BOLIVAR POND DAM
MA 00807

PHASE I INSPECTION REPORT
NATIONAL DAM INSPECTION PROGRAM

DRAFT REPORT REVIEW COMMENTS

Bolivar Pond DAM, IDENTITY NO. MA 00807
F&M BRANCH

PLAN VIEW OF DAM SITE

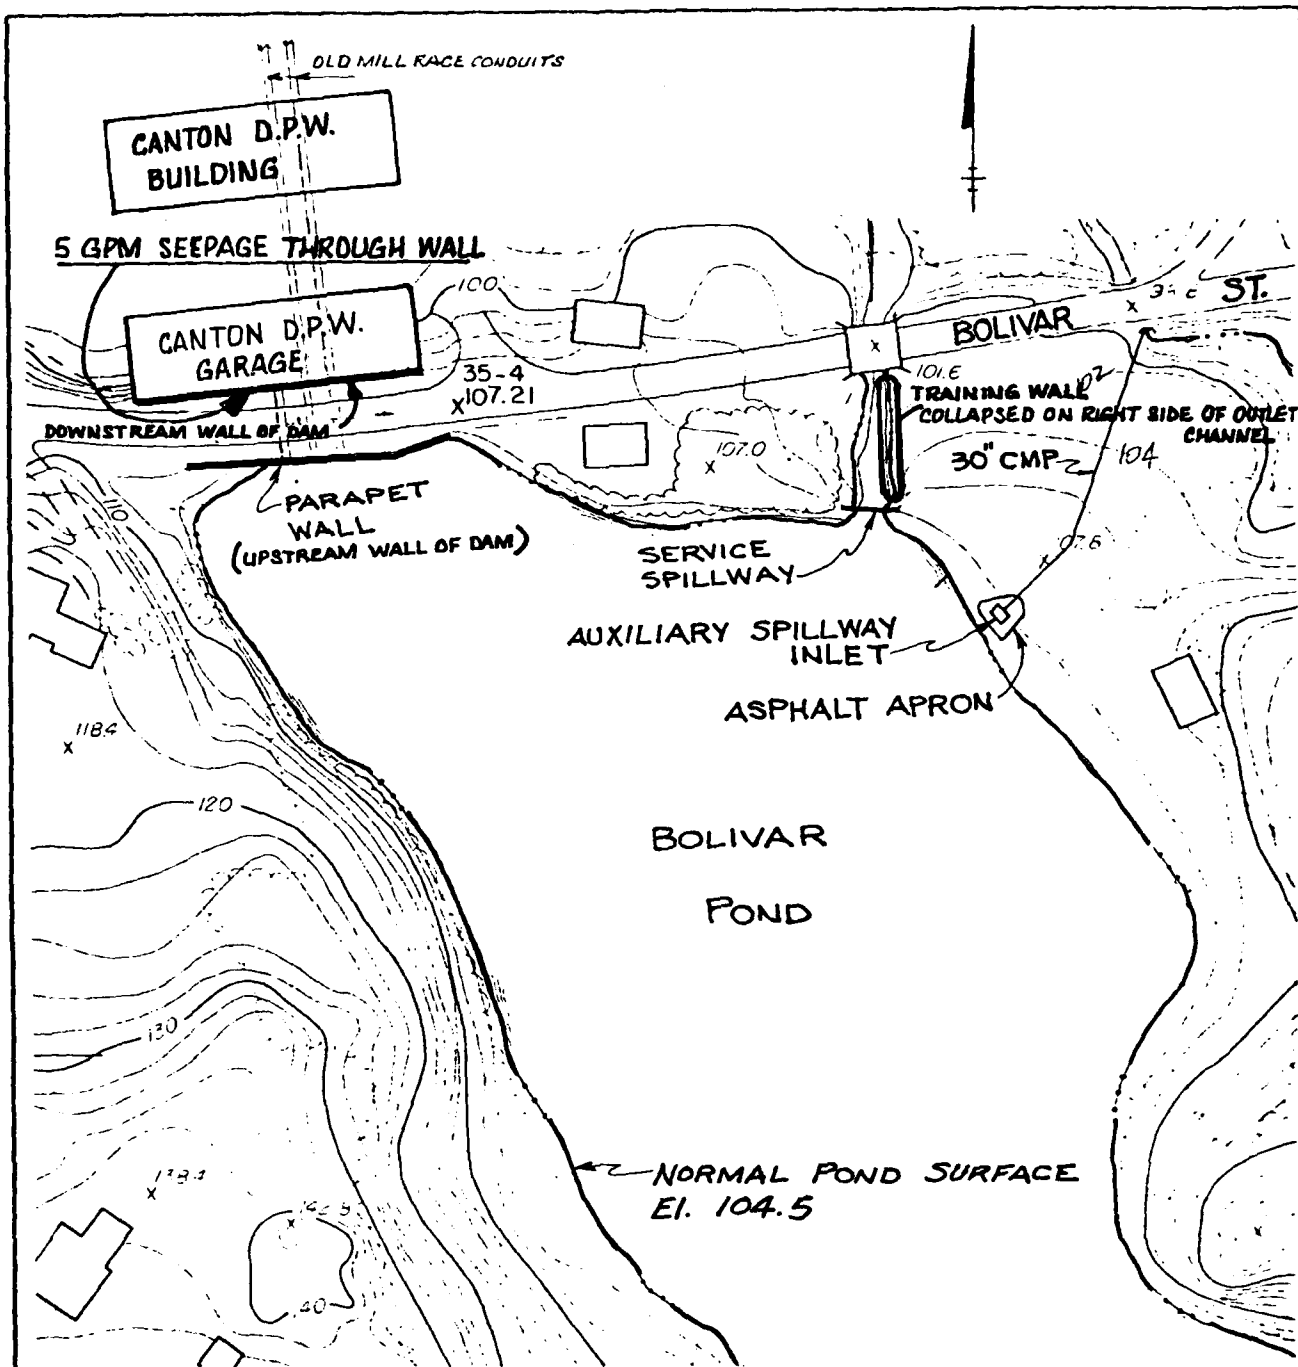
Show area of seepage in building on photo plan.
